### **3.4 Land Use and Zoning Comments and Responses**

**Figure 3.4-1: Building Heights in the Project Vicinity**  
 Buena Vista Teutonia PUR  
 City of Yonkers, Westchester County, NY  
 Base: NYS GIS Clearinghouse, 2009 Orthoimagery  
 Scale: 1" = 1,000'

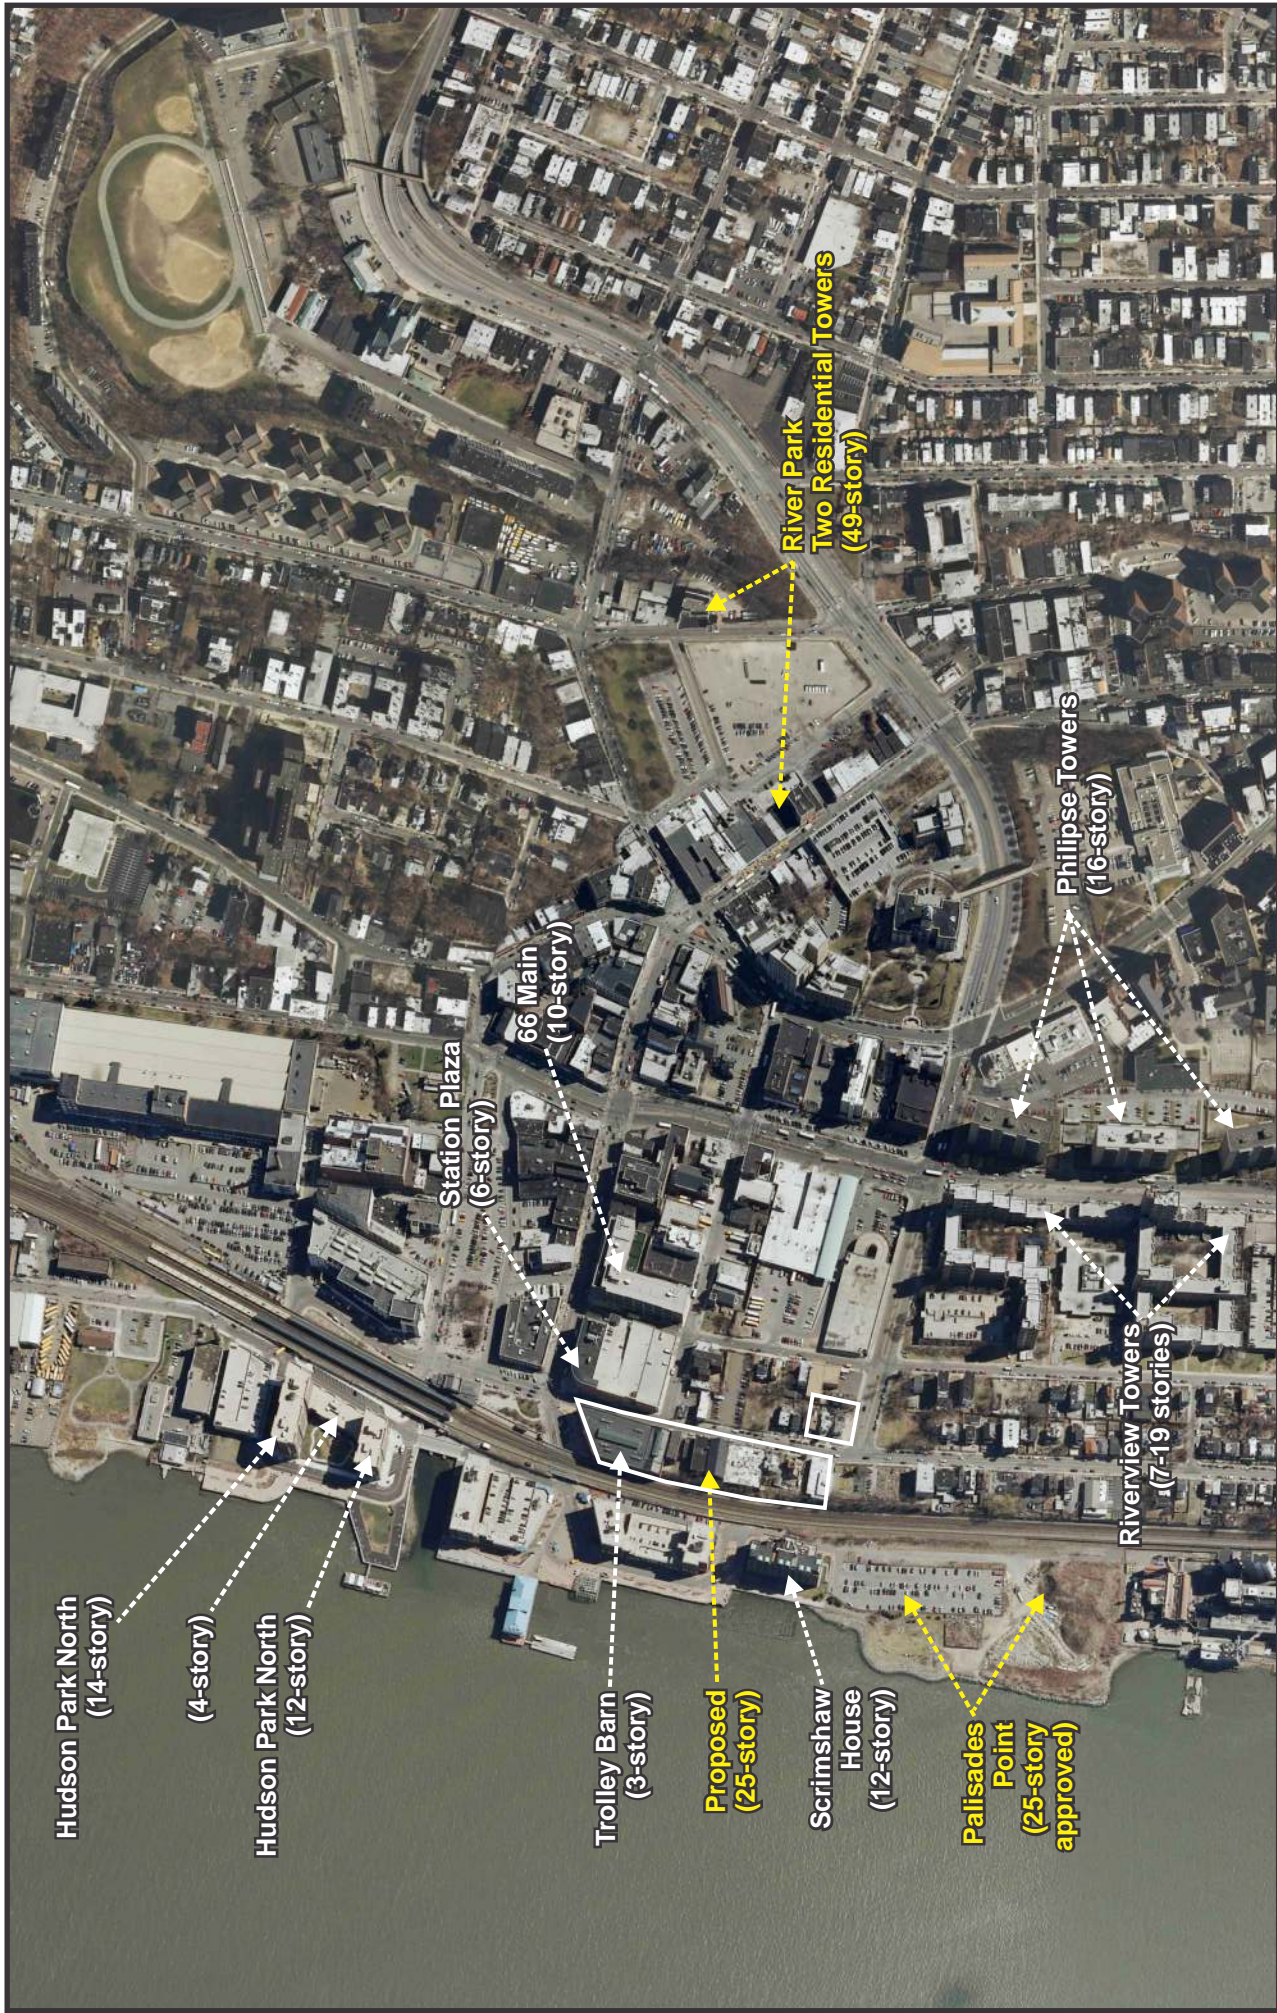
Figure 3-4.2a Show approved/not built in a different color. Missing heights for the Riverview projects.

**Response 3.4-58:** *The revised figure is provided in this FEIS as Figure 3.4-1 Building Heights in the project Vicinity.*
